AGENDA ITEM 13
PLANNING & DEVELOPMENT SERVICE
PLANNING DIVISION
455 Mountain Village Blvd.
Mountain Village, CO 81435
(970) 728-1392

TO: Mountain Village Design Review Board

RE: Consideration of a Design Review: Final Architecture Review for a new Single-Family Detached Condominium on Lot 165 - Unit 7, 170 Cortina Drive, pursuant to CDC Section 17.4.11.

1 SNOW MELT - LOWER LEVEL
1/8" = 1'-0"

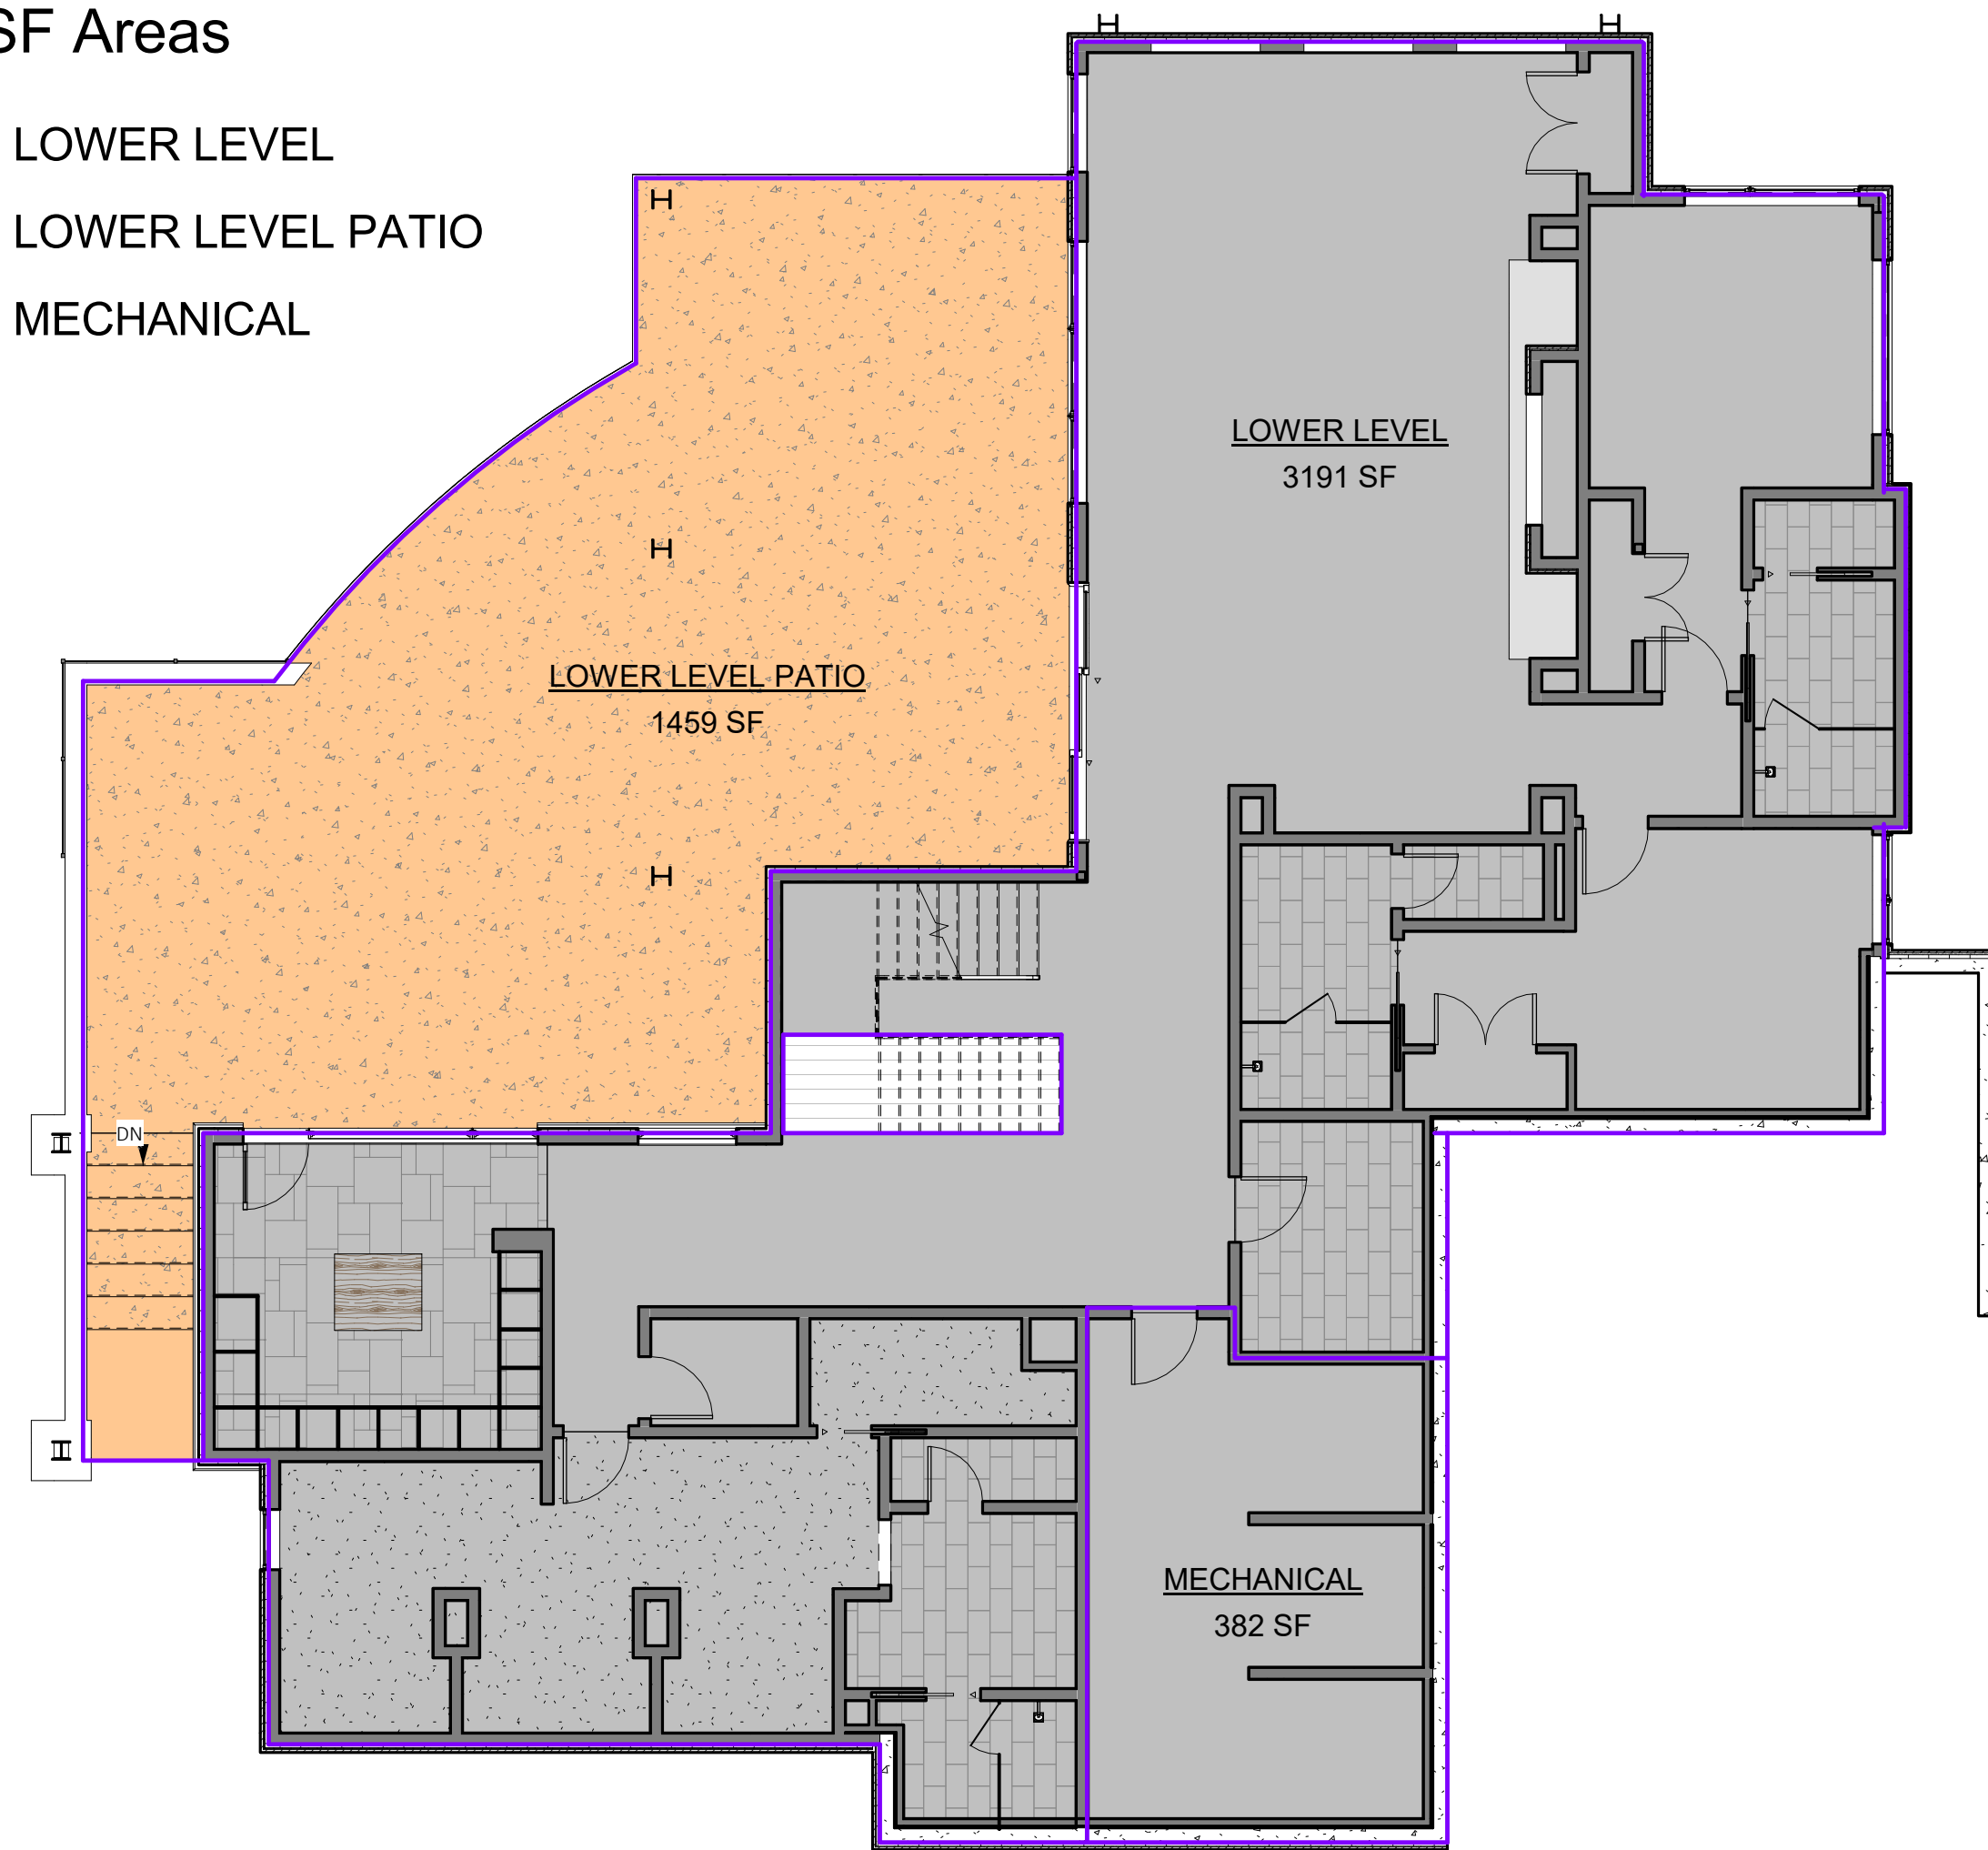
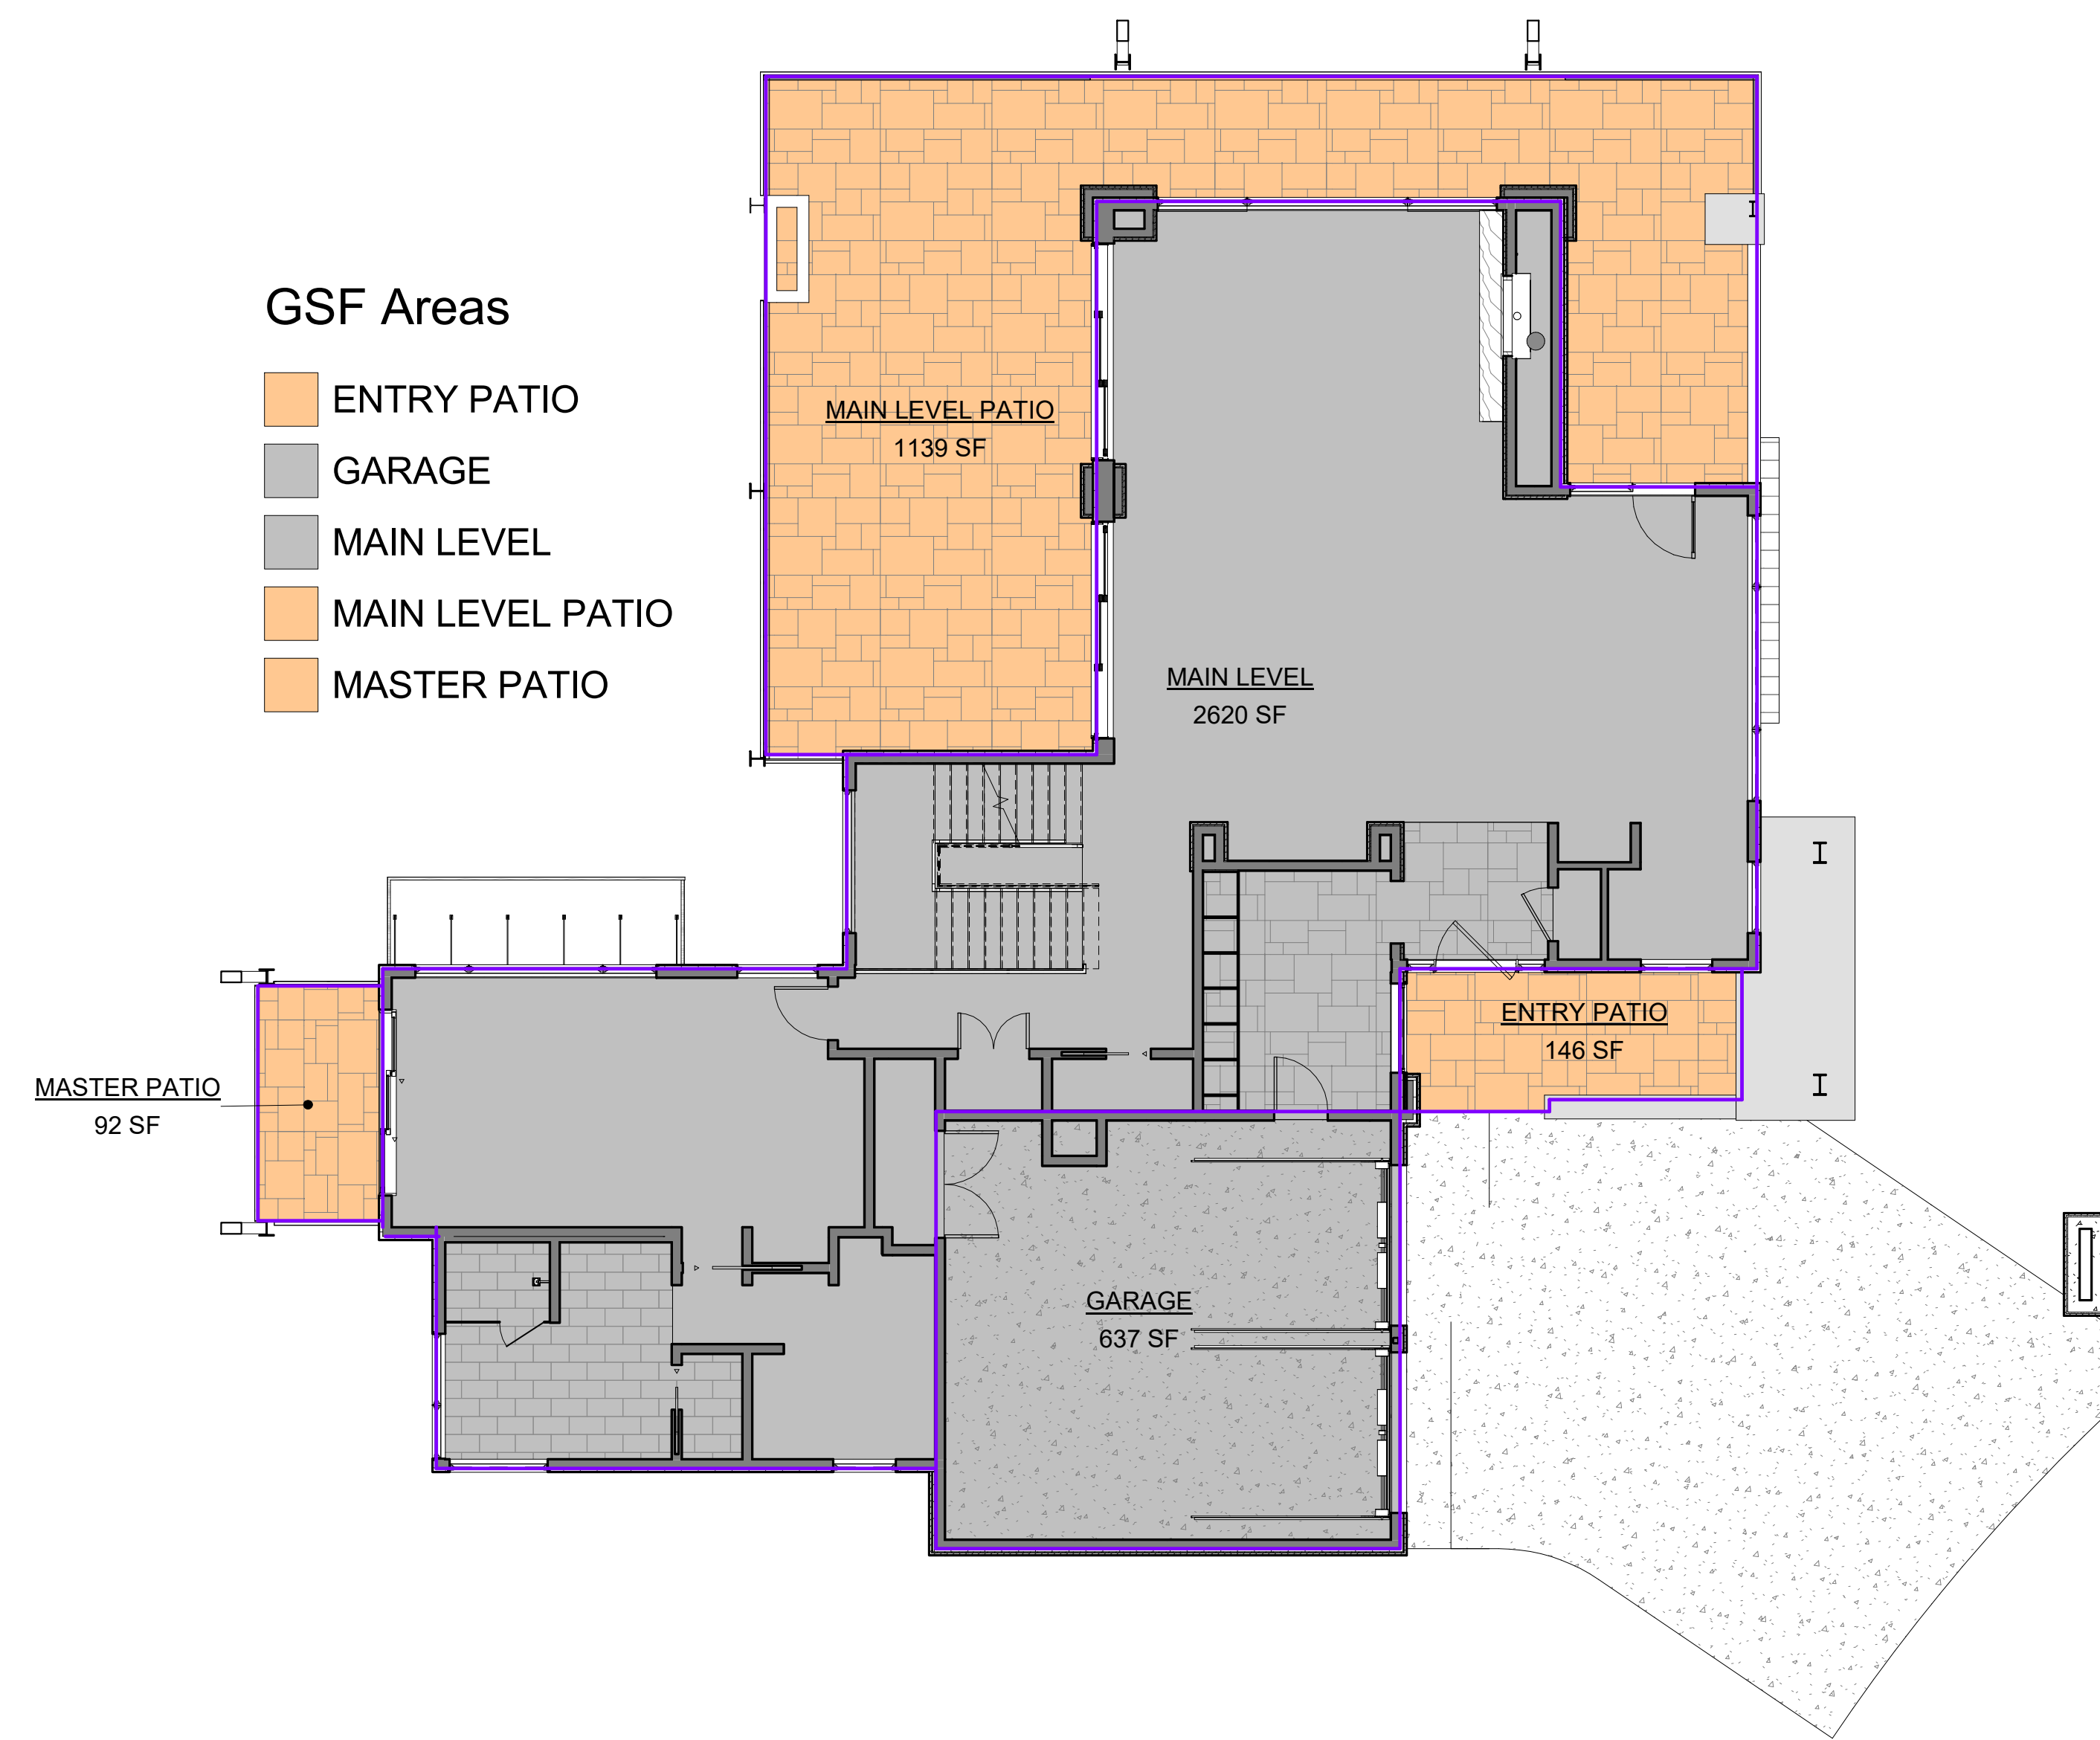
The applicant's plans have been updated to demonstrate areas of snowmelt and is currently proposing 2836 square feet. Due to the amount, this will require additional REMP fees or energy off-sets such as PV solar.

C1-0.2
 DRB DRAINAGE

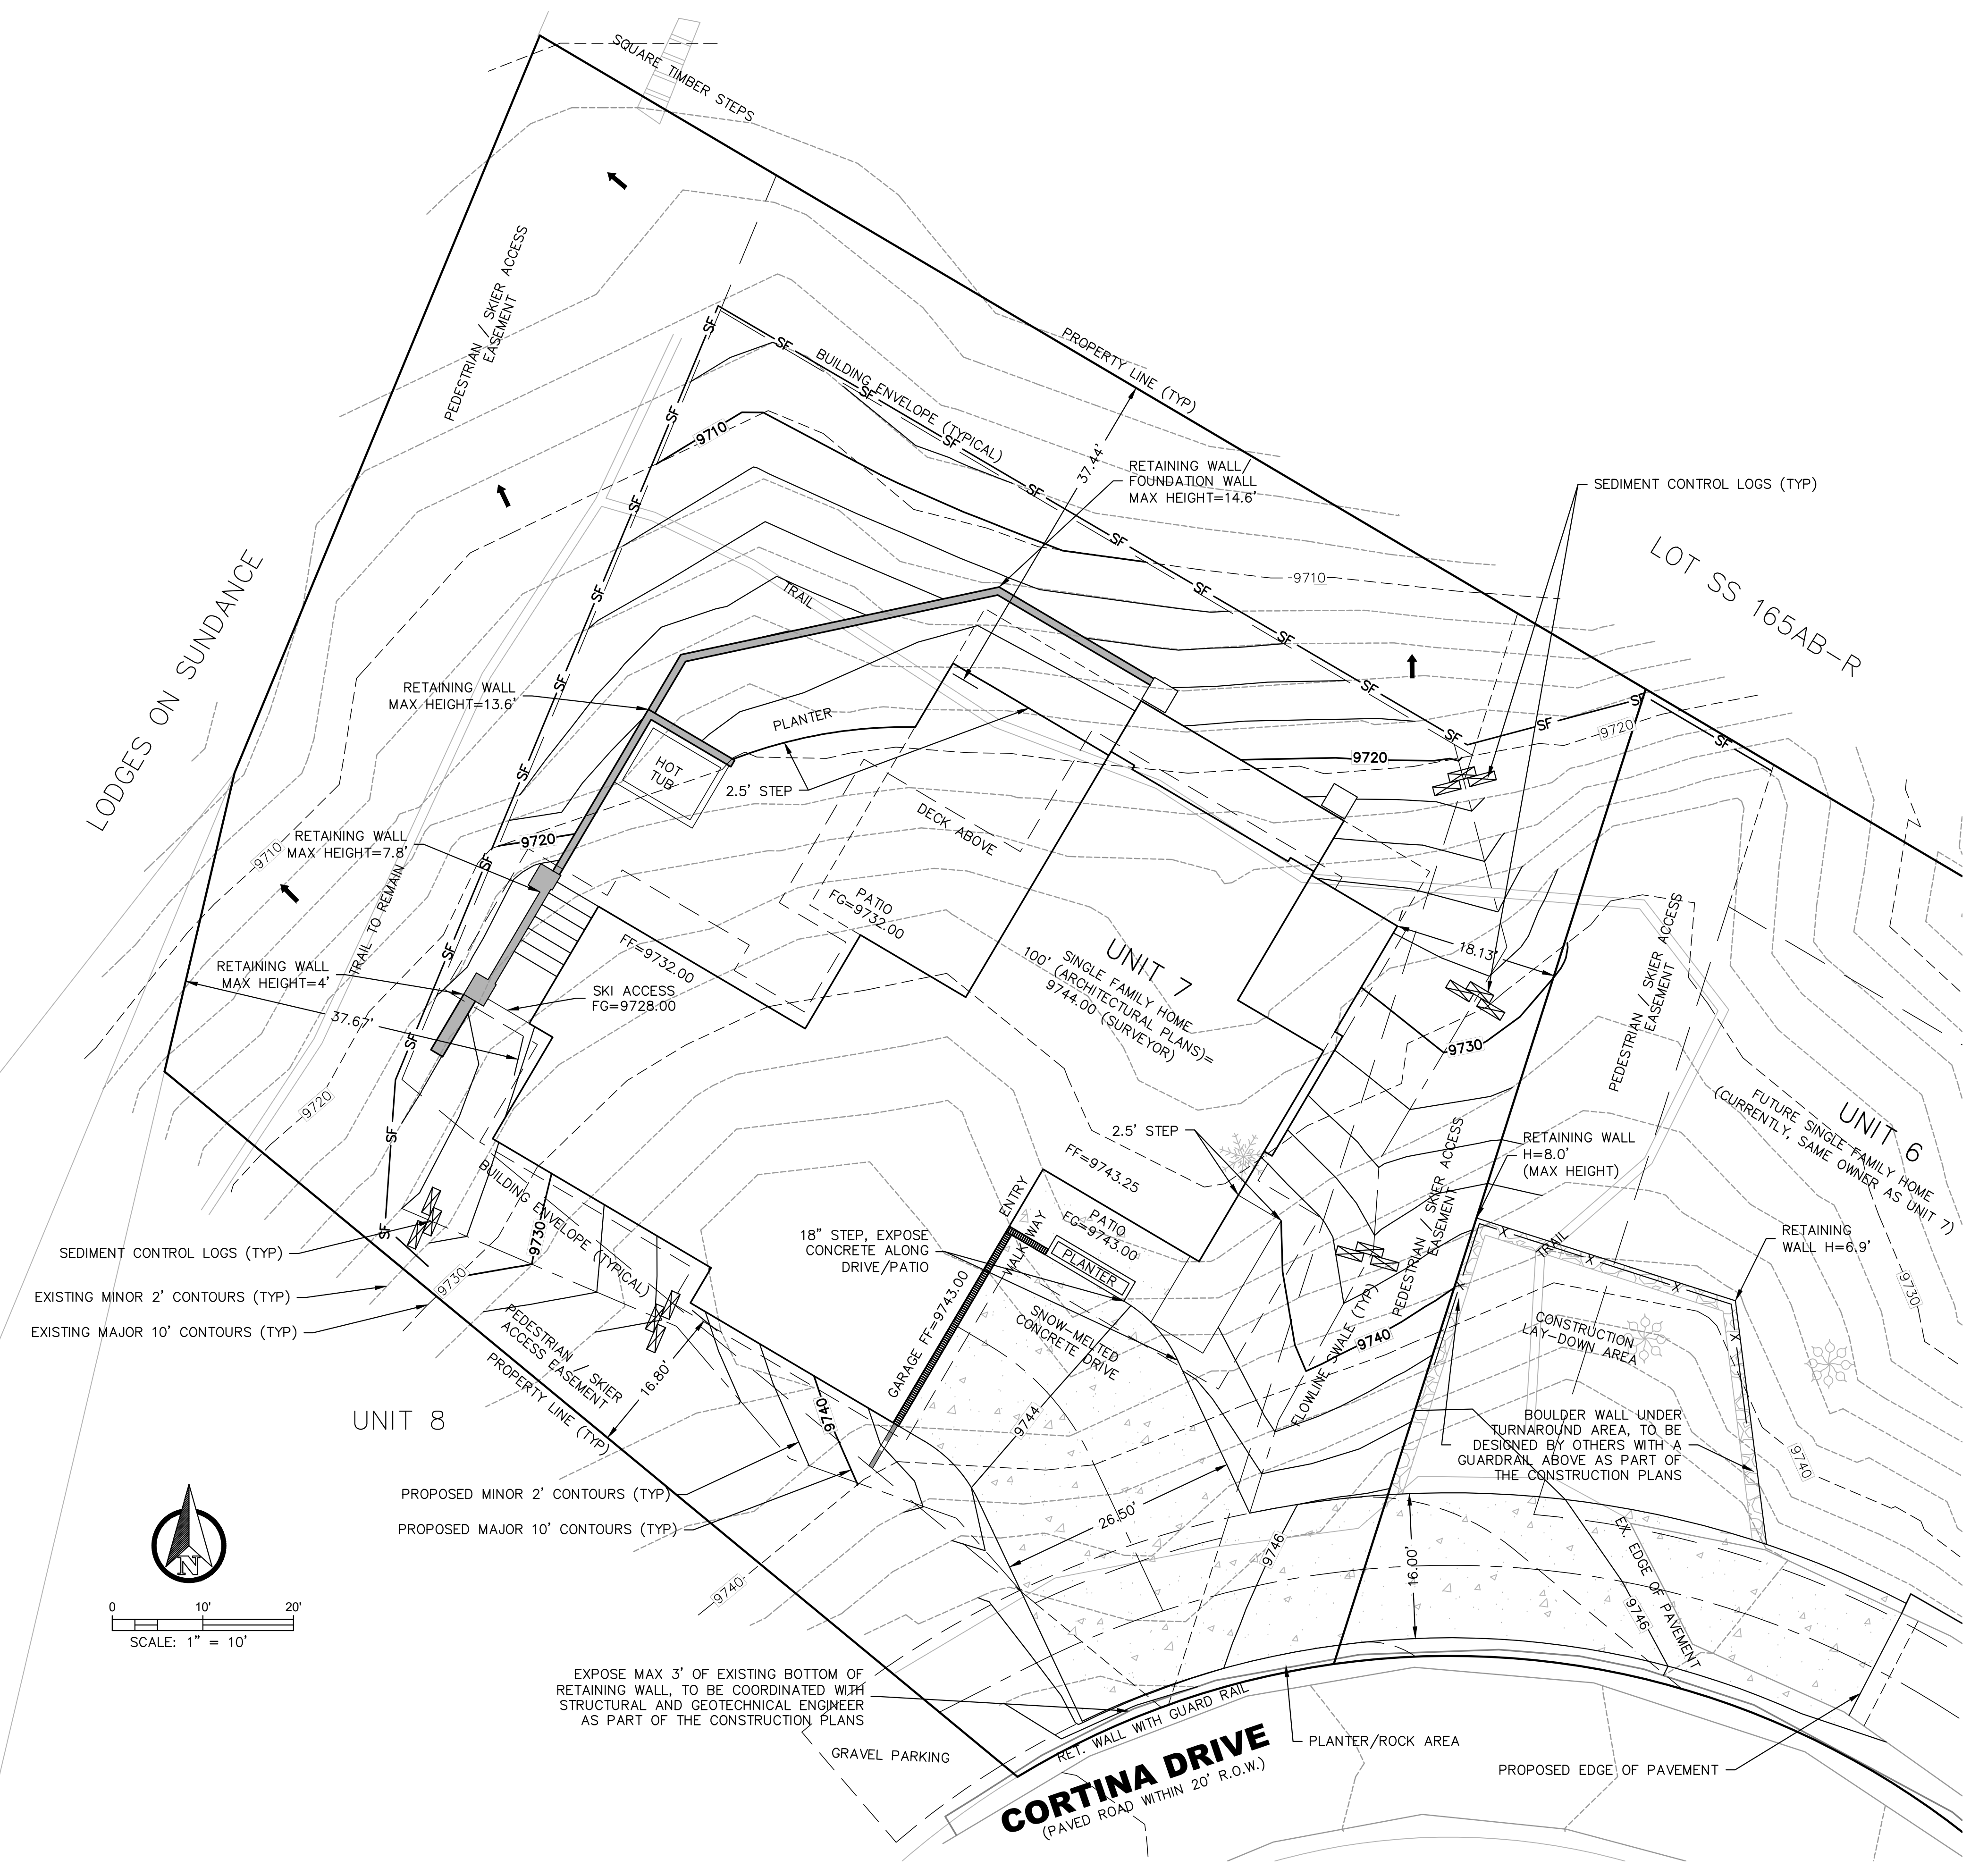
- *Drainage: On page C1-01, the civil drawings show a small portion of a trench drain that crosses the setback area. It appears that this encroachment is below grade.*
